Overview: Production error in version 1.0 harnesses; The immobilizer wire (orange/black) is in pin position #4 instead of pin position #5. Although an effort to correct the issue was made, some quantity of harnesses did get shipped before the issue was spotted. We are advising to inspect the harness BLADE connector before attempting to install harness or program the module. This issue is not known to affect the version 2 harnesses, which require no modification.

MODIFICACIÓN REQUERIDA PARA APLICACIONES A/T, SÓLO CON ARNÉS v 1.0

FTI-STP1: Notas de instalación y configuración

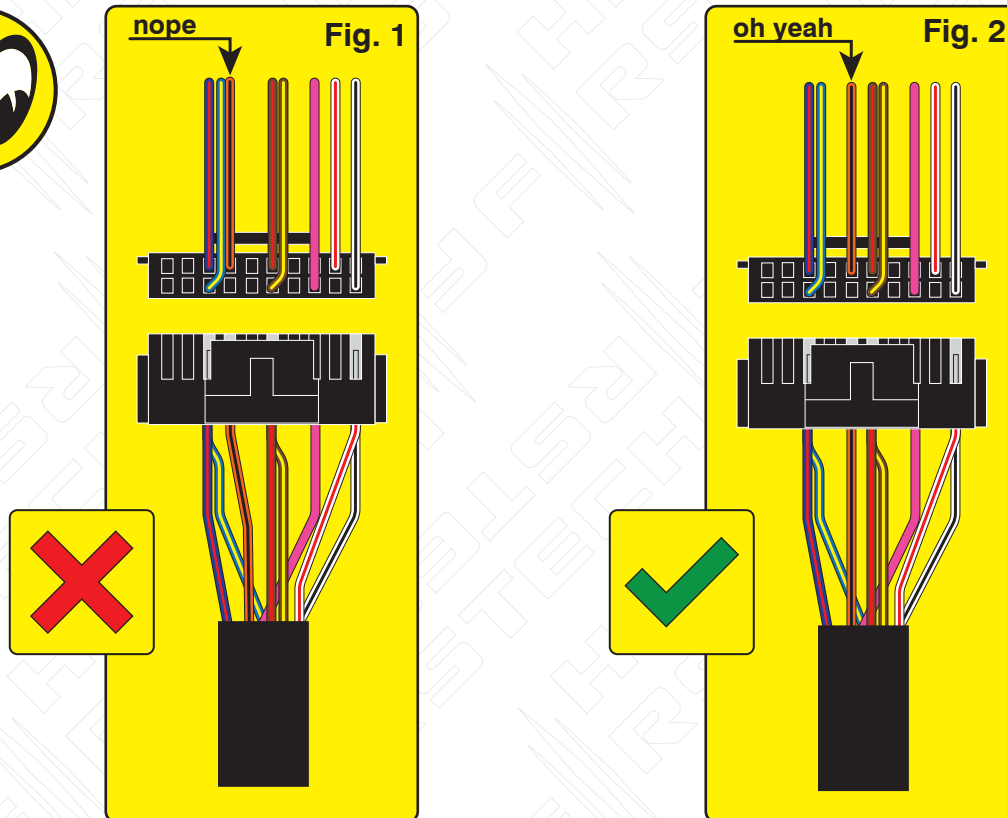
Issue: Module fails to program correctly to vehicle, does not allow the vehicle to be remote started.

Correction: Step 1.) Locate the orange/black wire and confirm whether it is positioned as illustrated in Fig. 1 or Fig. 2. If the wire is as illustrated in Fig.1, proceed with Step 2 through 5 and complete the repair procedure outlined, if the wire is as illustrated in Fig. 2, correction is not necessary, proceed with harness installation and module programming.

Step 2.) Using a pick, lightly depress the catch that secures the terminal in the housing then remove the wire and terminal from the housing.

Step 3.) Using a fine tip razor or utility knife, insert the blade beneath the terminal catch and raise it slightly, so that it can be reused to secure the terminal when reinserted into the BLADE connector housing.

Step 4.) Refer to Fig. 2 for correct position of the orange/black wire (next to brown/red) then reinsert the terminal, pressing lightly until the catch 'snaps' into place, securing the terminal in the connector housing.

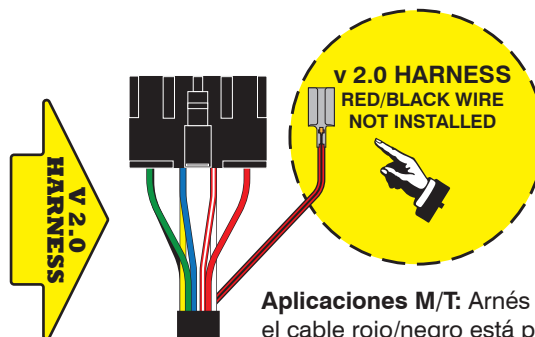
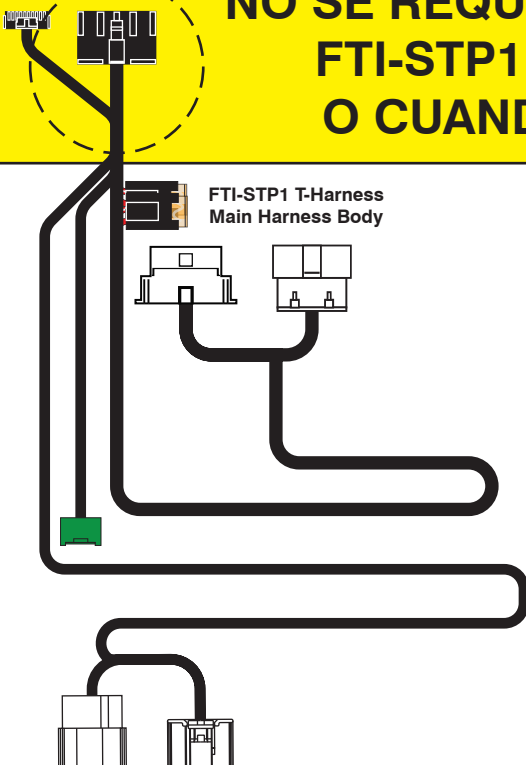
Descripción general: Las primeras versiones del arnés FTI-STP1 requieren modificaciones para aplicaciones de transmisión automática (AT), algunas del producto se pudo modificar antes del lanzamiento, pero una pequeña cantidad se lanzó sin modificaciones.

Problema: El arnés en T FTI-STP1 ha sido diseñado para ser compatible con A/T (transmisión automática) y M/T (manual), pero debido a un descuido en las primeras ejecuciones de producción, la selección se estableció por defecto en el modo M/T.

El uso de un arnés configurado para una aplicación M/T, en un vehículo equipado con A/T, podría provocar daños en el módulo del vehículo, se recomienda que el arnés vuelva al modo A/T antes de la instalación en vehículos equipados con transmisión automática.

Corrección: Localice el cable rojo/negro (+ embrague) proporcionado en el conector CN1 del conjunto del arnés principal. Corte el cable rojo/negro, ya sea al ras del conector CN1 o dejando suficiente cable expuesto para que pueda aislar y asegure los extremos del cable que quedan después del corte. Aísle cada uno de los extremos restantes del cable rojo/negro y asegúrelos para evitar cualquier posibilidad de cortocircuito. Si el cable rojo/negro ya ha sido desconectado, ninguna modificación adicional se requiere para aplicaciones A/T

NO SE REQUIERE MODIFICACIÓN CUANDO SE UTILIZA FTI-STP1 (v 1.0) ARNÉS EN APLICACIONES M/T, O CUANDO UTILICE EL ARNÉS FTI-STP1 (v 2.0)

Aplicaciones M/T: Arnés versión 2.0, el cable rojo/negro está pegado al arnés principal cuando se envía, y debe instalarse en el CN1 conector cuando está instalado.

Aplicaciones A/T: Deje el cable rojo/negro pegado al arnés, no es necesario para aplicaciones A/T
